**Final PRE-APPLICATION CONFERENCE  
Manning Subdivision (2024-015-PAC)**

Meeting conducted on Wednesday, July 10, 2024 at 2:00 p.m.

### **Site Plan Review Comments**

SCHEMATIC  
CUL-DE-SAC

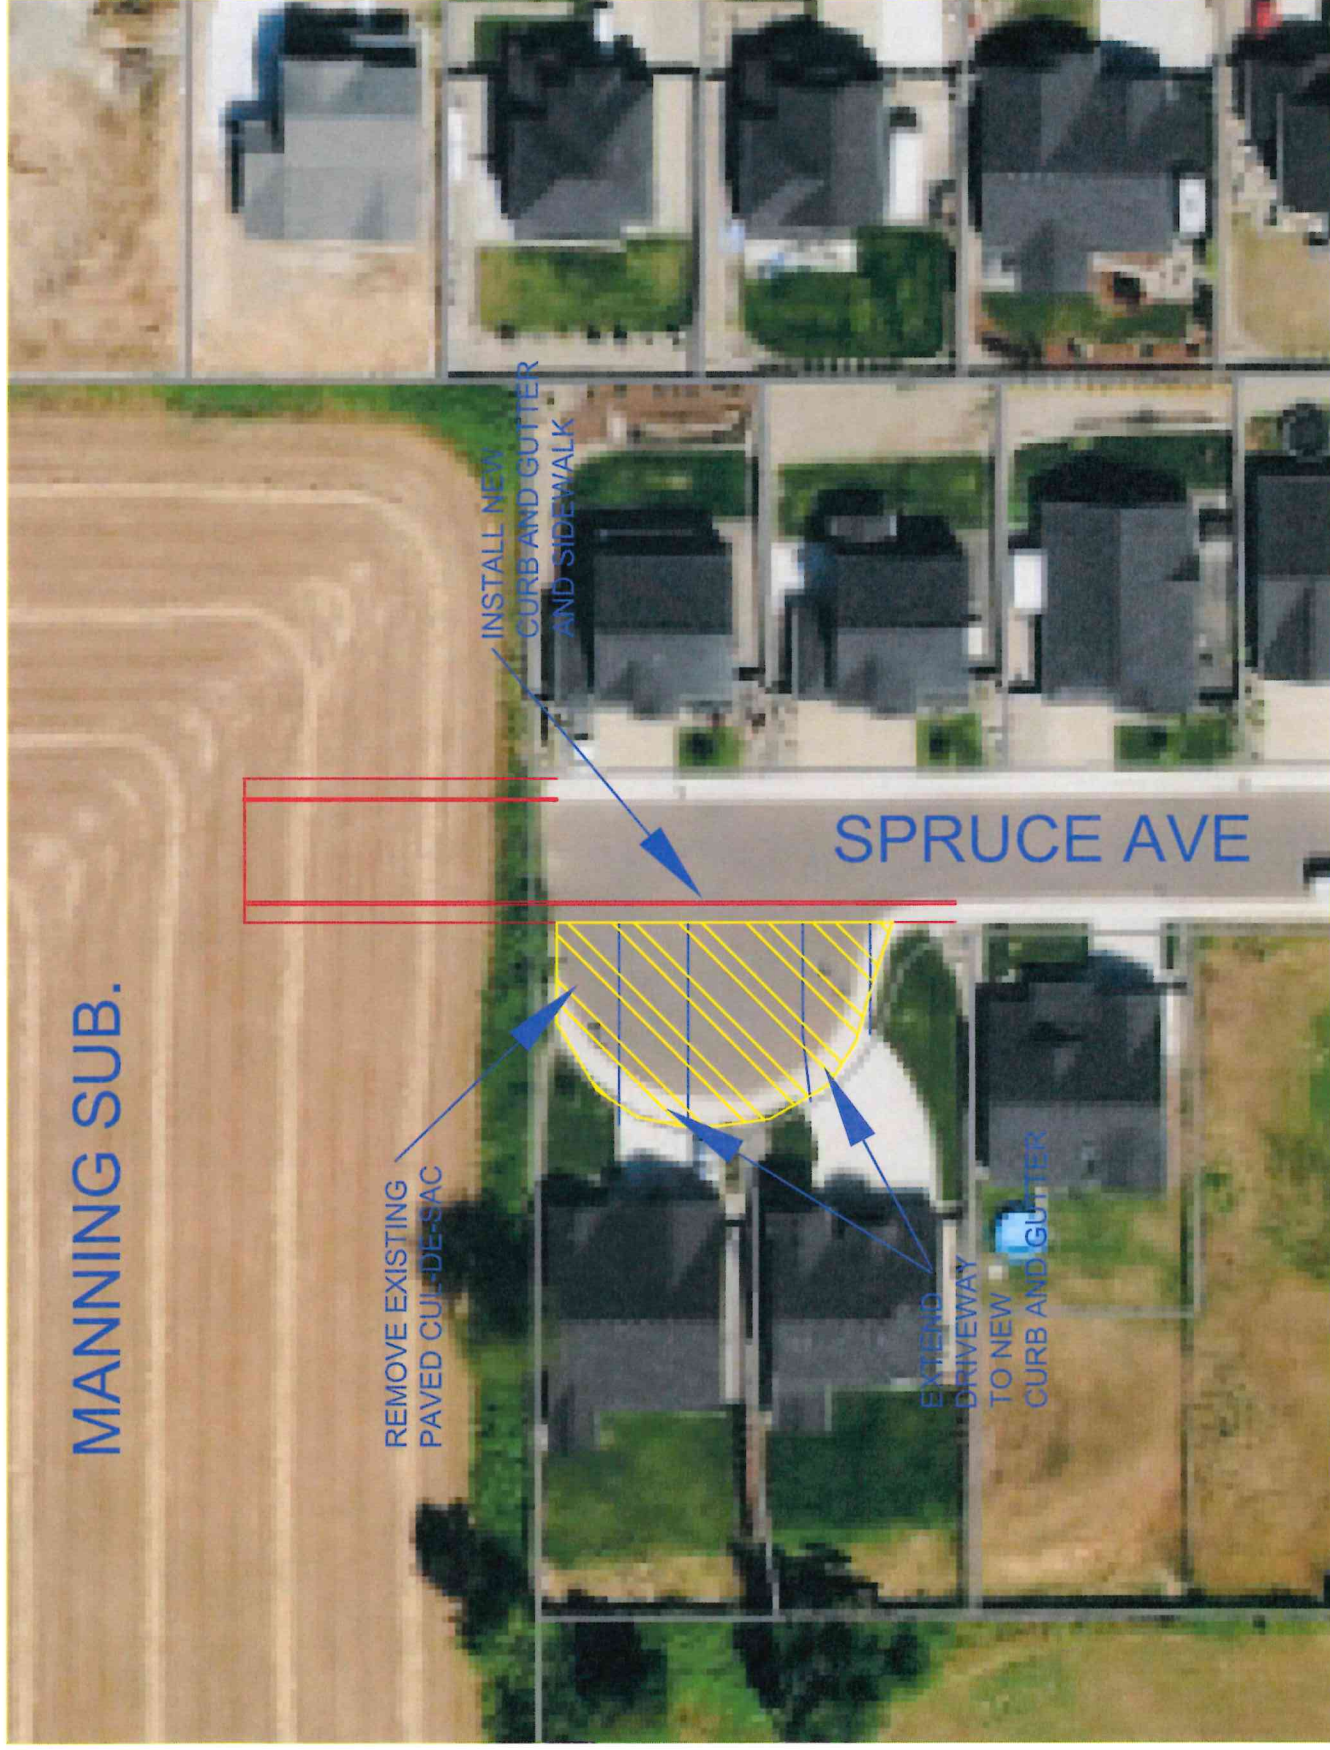
The applicant proposes to extend Spruce Avenue north to provide access to the site. The existing north end of East Spruce, south of the proposed subdivision, is an offset cul-de-sac. In the pre-application conference, the City Engineer discussed extending the Spruce Avenue, and leaving a this offset cul-de-sac to serve the existing houses. However, after discussion with the Public Works/Community Development Director and CCF&R, the city has decided that it may be unsafe for the residents, that live adjacent to this cul-de-sac that will now be in the middle of a through street.

The city will require that the existing cul-de-sac be removed, and install a new curb and gutter along the existing west side of the Spruce Avenue to be the same width of the local standard. Driveways along the existing cul-de-sac will need to be removed, and a new concrete approach poured for the two homes that abut the cul-de-sac. See the schematic example.

REMOVE EXISTING  
PAVED CUL-DE-SAC

INSTALL NEW  
CURB AND GUTTER  
AND SIDEWALK

EXTEND  
DRIVEWAY  
TO NEW  
CURB AND GUTTER

ST-13A

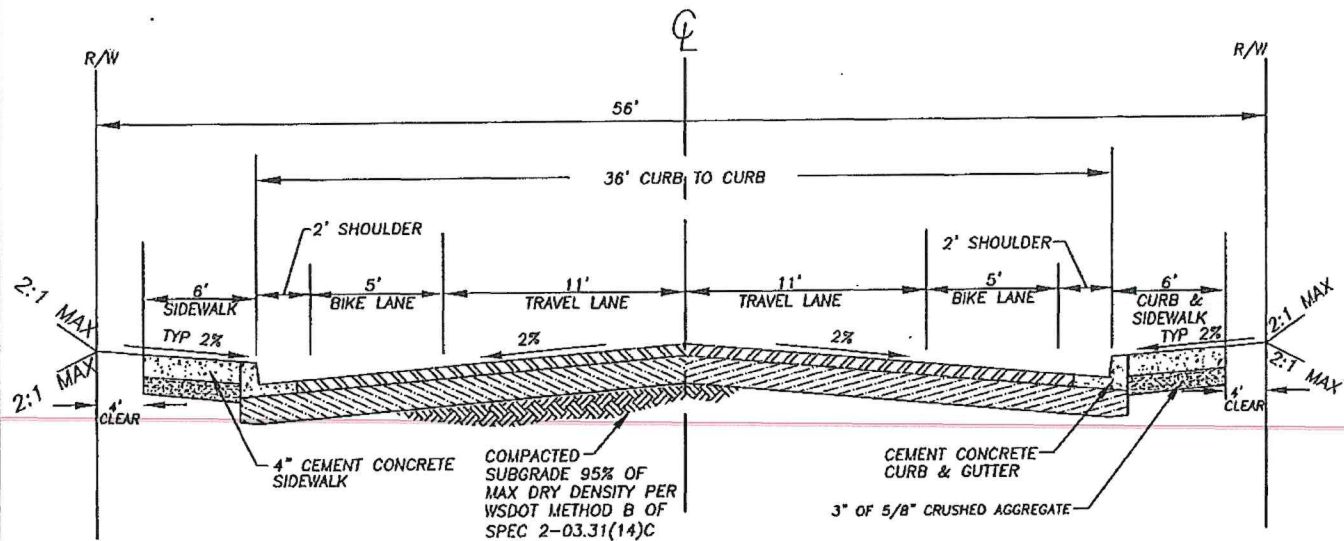
The proposed development will have multiple access points to public roadways. NW 339th Street is classified as a major collector and the site frontage will be improved per ST-13A. Spruce Avenue is stubbed to the southern property line and is classified as a local access street. This roadway will be extended through the site and will connect to NE 339th Street. The cul-de-sac eyebrow just to the south of the site is not proposed to be modified with the extension of Spruce Avenue to the north. 8th Street is stubbed to the eastern property line and is classified as a local access street. This roadway will be extended into the site with improvements per ST-15A. Willow Avenue is proposed along the western end of the site, this roadway is proposed as a minor collector per ST-13B. Lots are proposed to directly access this street. Elk and Lynx streets are proposed public roadways and will be built to ST-15A.

*NE 339<sup>th</sup> Street is classified as a Major Collector per the Capital Facilities Plan. The Rural Major Collector per the Engineering Standards consists of a 40-foot wide paved road. General roadway and right-of-way standards shall apply providing half street improvements per LCMC 12.10.090.*
